Project	IEEE 802.16 Broadband Wireless Access Working Group < http://ieee802.org/16 >	
Title	Supplementary Changes for Comment #30 in 80216-04/20	
Date Submitted	2004-04-30	
Source(s)	Lei Wang Wi-LAN Inc. 2891 Sunridge Way, NE Calgary, AB, Canada, T1Y 7K7 Jonathan Labs Wavesat Wireless, Inc.	Voice: (403)273-9133 Fax: (403)273-5100 Email: LeiW@wi-lan.com
Re:	This is a contribution to IEEE 802.16-REVd.	
Abstract	This contribution describes the proposed changes to not have multiple UL channels for a DL channel in 802.16REVd.	
Purpose	To remove the unnecessary complexity in 802.16 systems.	
Notice	This document has been prepared to assist IEEE 802.16. It is offered as a basis for discussion and is not binding on the contributing individual(s) or organization(s). The material in this document is subject to change in form and content after further study. The contributor(s) reserve(s) the right to add, amend or withdraw material contained herein.

Supplementary Changes for Comment #30 in 80216-04_20

This document describes the supplementary changes for comment #30 in 80216-04_20.

Figure 56—Obtaining uplink parameters

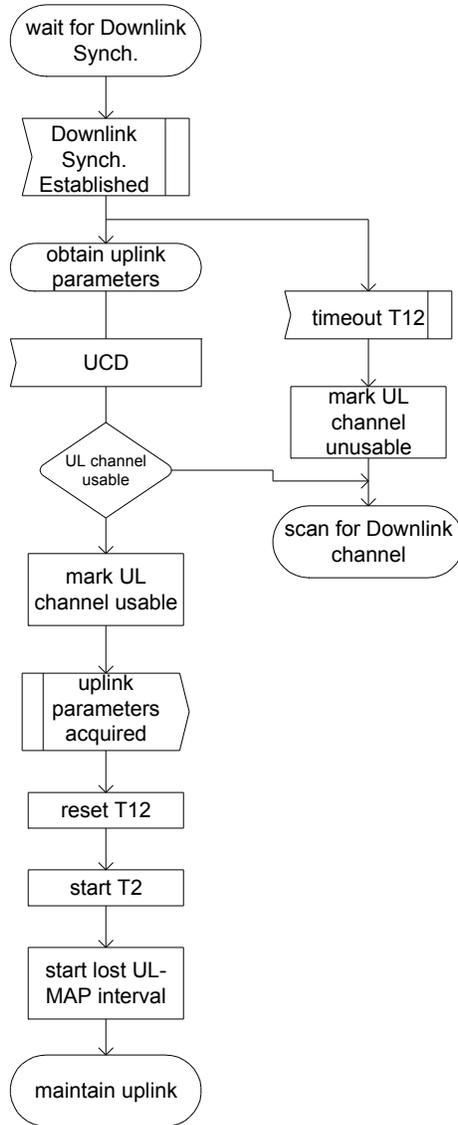
After synchronization, the SS shall wait for a UCD message from the BS in order to retrieve a set of transmission parameters for a possible uplink channel. These messages are transmitted periodically from the BS for ~~the all available~~ uplink channels and are addressed to the MAC broadcast address. ~~The SS shall determine whether it may use the uplink channel from the channel description parameters.~~

~~The SS shall collect all UCDs which are different in their channel ID field to build a set of usable channel IDs.~~ If no uplink channel can be found after a suitable timeout period, then the SS shall continue scanning to find another downlink channel. The process of obtaining uplink parameters is illustrated in Figure 56.

Figure 57—Maintain uplink parameters, ~~single uplink case, ChID=i~~

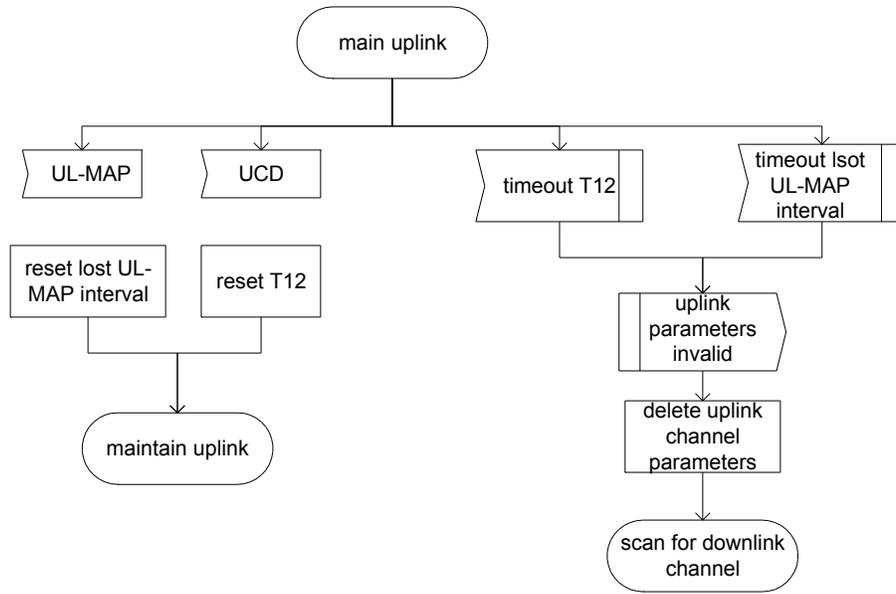
The SS shall perform initial ranging at least once, per Figures 58 and 59. If initial ranging is not successful, ~~then the next channel ID is selected, and~~ the procedure is restarted from ~~UCD extraction scanning to find another downlink channel~~. ~~When there are no more channel IDs to try, then the SS shall continue scanning to find another downlink channel.~~ The SS MAC is considered to have valid uplink parameters as long as it continues to successfully receive the UL-MAP and UCD messages. If at least one of these messages is not received within the time intervals specified in Table 295, the SS shall not use the uplink. This is illustrated in Figure 57.
